MEMORANDUM

TO: MASTER PLAN AND ZONING COMMITTEE
FROM: LINDSAY BELL, AICP, SENIOR PLANNER
THRU: BARBARA MCBETH, AICP, CITY PLANNER
SUBJECT: CONSIDERATION OF REQUEST TO AMEND CONSENT JUDGMENT: JSP25-12 NOVI ACRES
DATE: APRIL 10, 2026

JSP25-0012 NOVI ACRES

PEA JOB NO. 2021-0449
P.M. JPB
D.N. JKS
D.S. JKS
DRAWING NUMBER: C-4.1

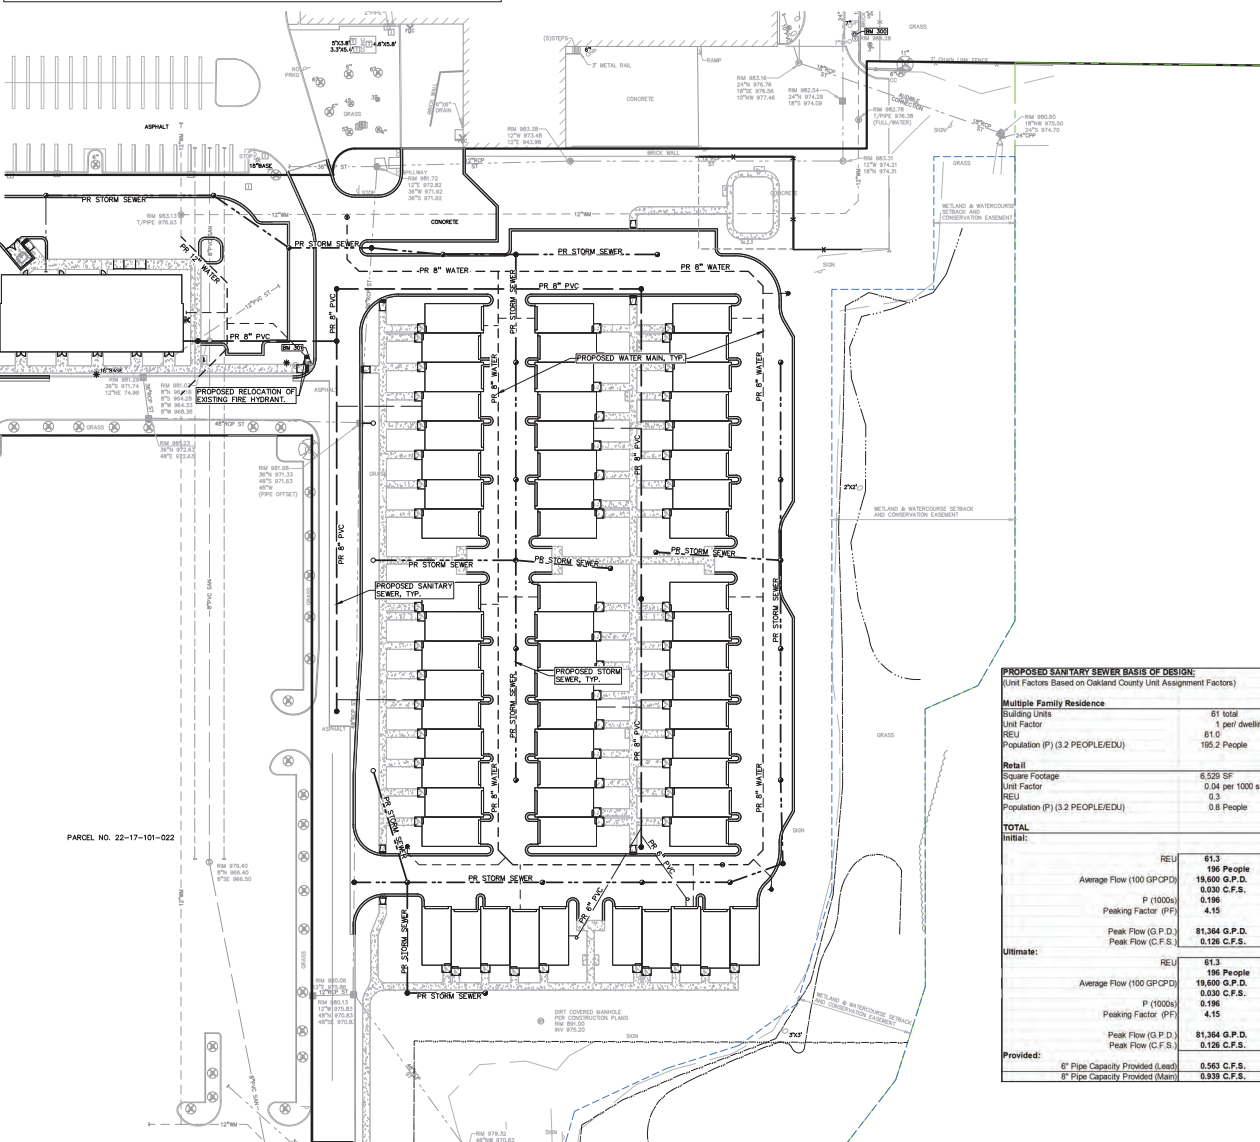
- 1. Please add the silt fence to protect the wetland to the Grading Plans.**
 - Designer Response: Silt Fence has been added to C4.1 and C4.2 for wetland protection.
- 2. Please correct the table on T-1.1 where it states that trees #741-814 are exempt from replacement due to their size. Those are all woodland replacement trees from the Grand Promenade/Novi Promenade projects and must be replaced if they are removed, even if they are not 8 dbh.**
 - Designer Response: The tree preservation plan no longer shows #741-841 as exempt trees.
- 3. See the Merjent letter for a complete review of woodlands and wetlands**
 - Designer Response: Noted. No comments.
- 4. Please show zoning of parcel and adjacent parcels on Landscape Plan or add to Alta Survey**
 - Designer Response: Zoning information is shown on C3.0 Overall Site and L-1.0.

DRAWING NUMBER:
C-6.1

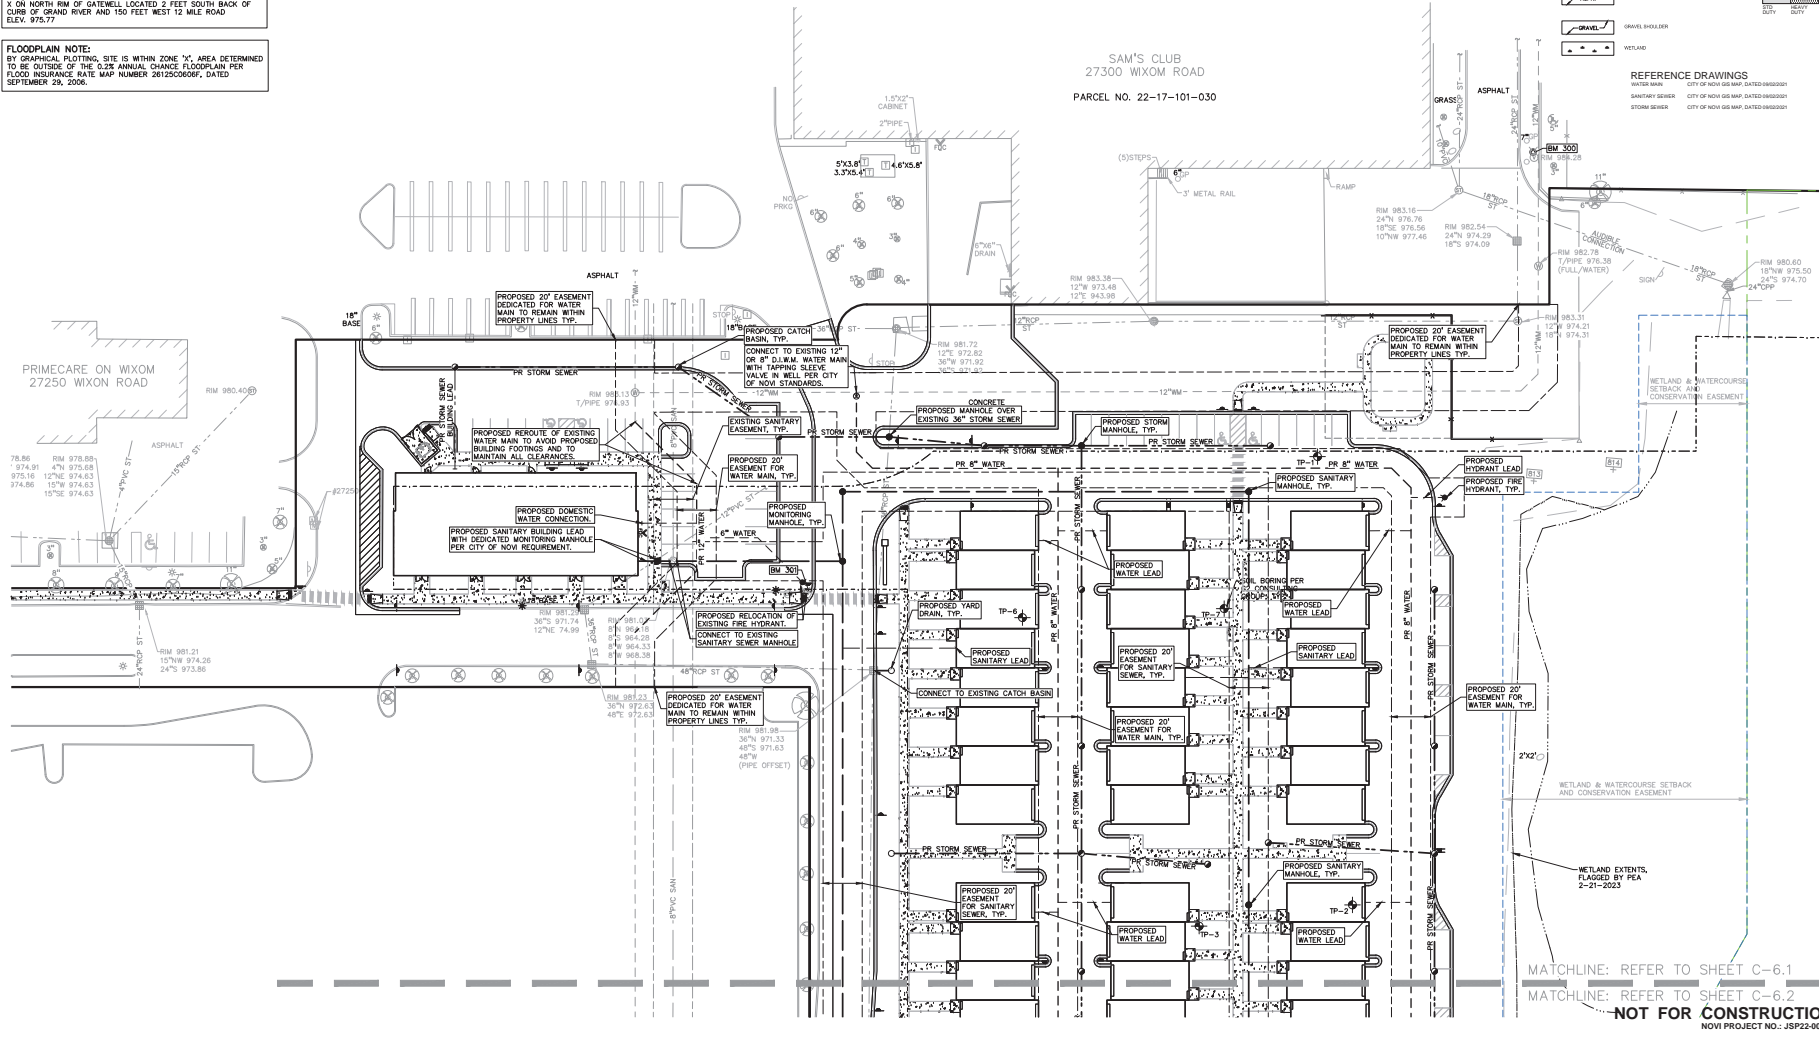
- Designer Response: Revised per comment.
- 14. A tapping sleeve, valve and well is required at the connection to the existing water main.**
 - Designer Response: Added on Sheet C-6.1.

DRAWING TITLE
PRELIMINARY LANDSCAPE PLAN-OVERALL

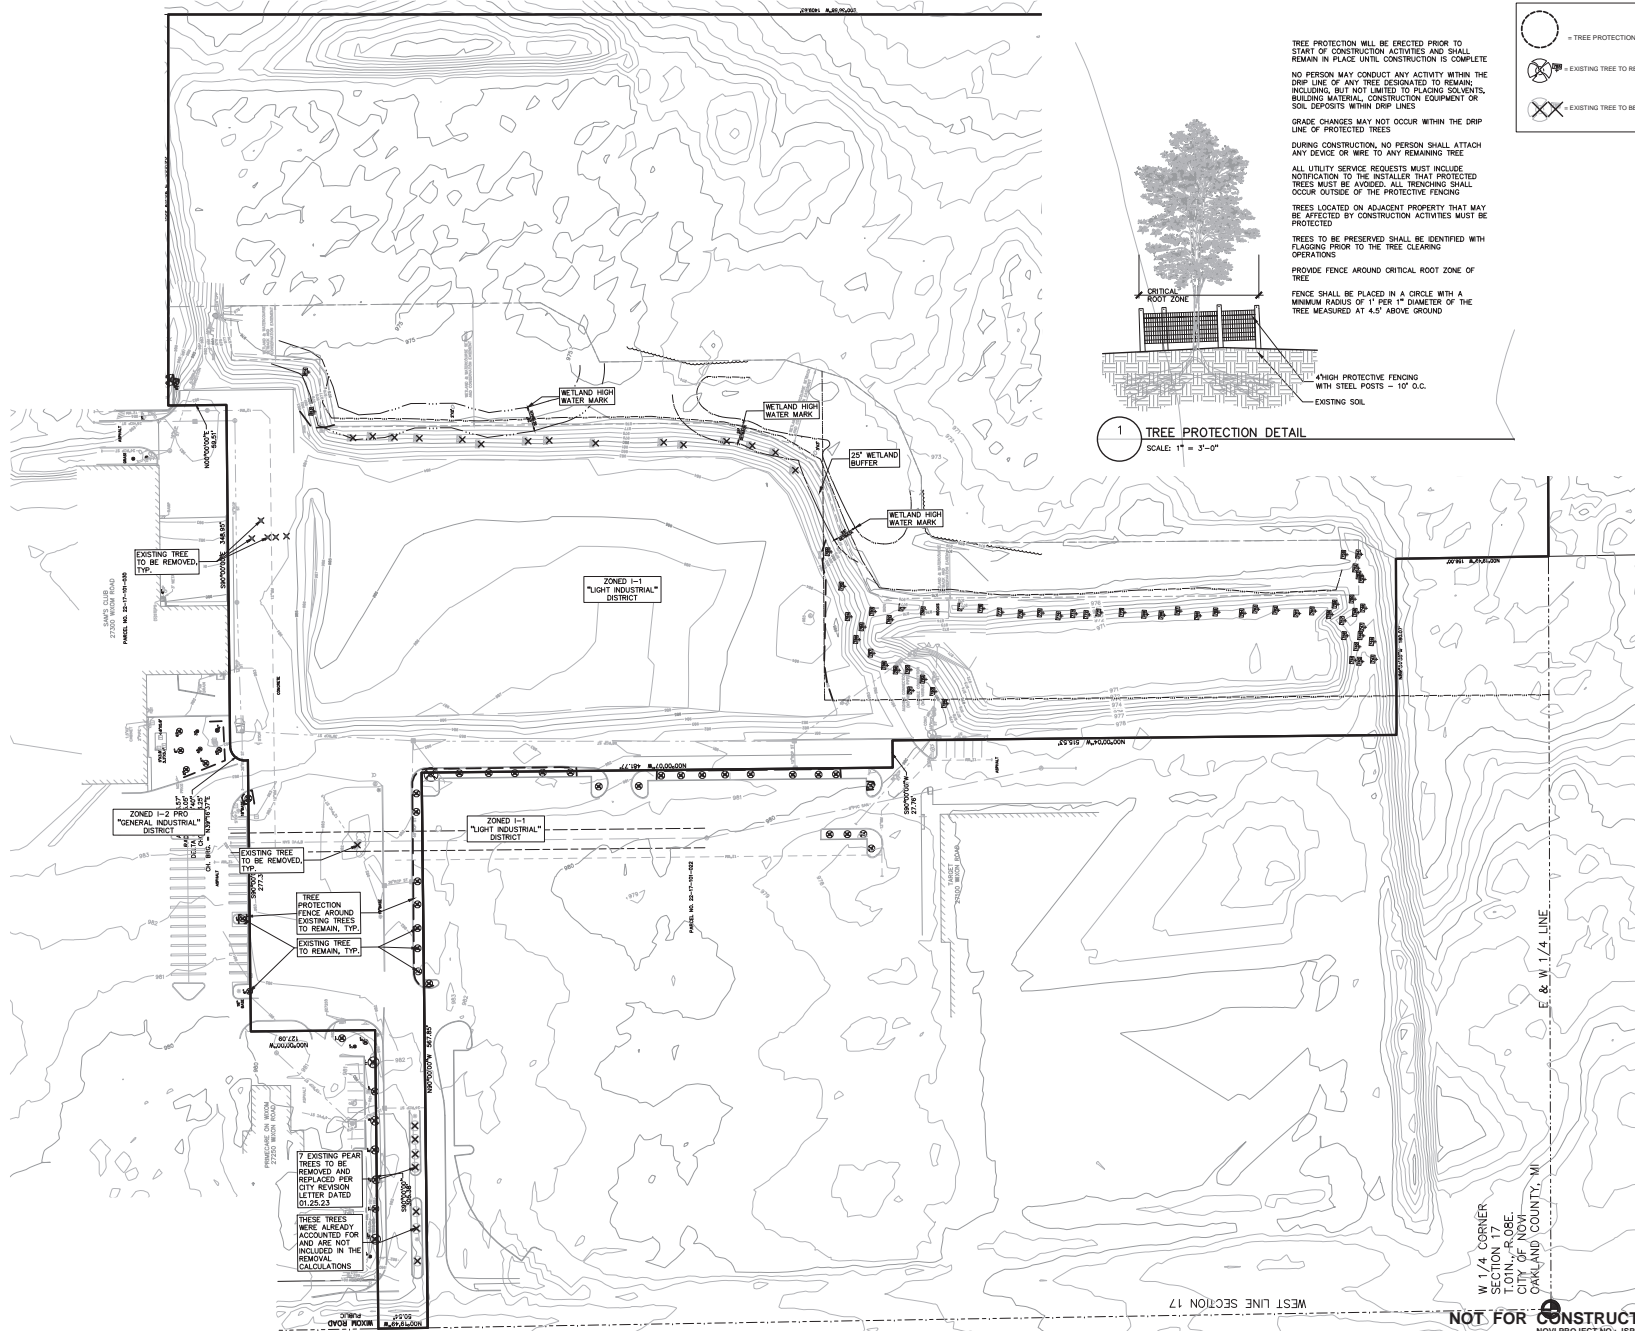
- 12. Please correctly label all islands that can count towards the requirement.**
 - Designer Response: All islands labelled with square footage on L-1.0
